MAS003715\_A RU 23-64

# Rapid Update 585 MC20 – Rear axle shaft replacement

**DATE:** NOVEMBER 14 2023

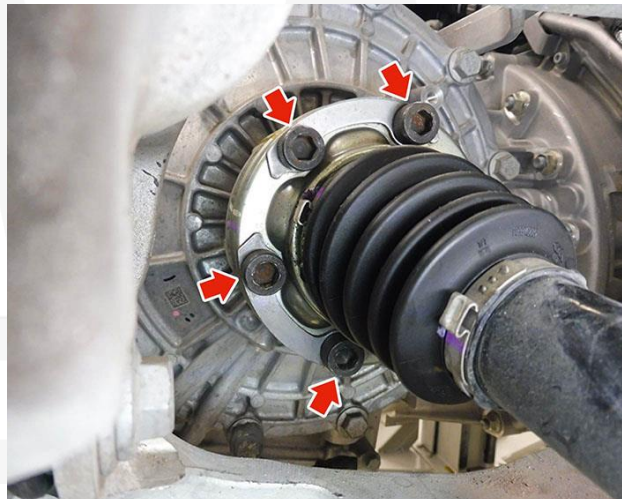
Certain Maserati MC20 and MC20 Cielo (M240) MY22 MY23 listed in MODISCS+ are involved in a Rapid Update to replace both rear axle shafts.

This replacement is necessary because the development of the project has led to an improvement of the component, guaranteeing better performance and a longer lifespan. Therefore, to offer our customers the best available technology, it has been decided to replace and update the vehicles that have already been sold.

1. Always check ModisCS+ to see if the vehicle is involved in this action and if it has not been previously performed.
2. Disconnect the battery by following the relative procedure in the workshop manual:
  - **8.20.001.0 BATTERY Disconnect-Connect Power Supply**
3. **Completely remove and replace** the left and right drive shafts following the instructions in the workshop manual. (**Section 03.10 - 1 GEARBOX HOUSINGS**)
  - **03.21.002 - COMPLETE RH HALF SHAFT - Removal/refitting or replacement**
  - **03.21.003 - COMPLETE LH HALF SHAFT - Removal/refitting or replacement**

**NOTE:** Please visually inspect the inner shaft boot at the differential joint and its caps for any presence of grease and or torn boot. Be sure to clean all cap holes and surfaces from any residual grease.

Tightening torque of the axle shaft screws - 03.10.145	
<b>1. TIGHTENING TORQUE</b>	30N ·m (22.1 ft-lb)
<b>2. ANGLE</b>	90° (1.57 rads)
<b>3. CONTROL TORQUE</b>	45N ·m (33.2 ft-lb)
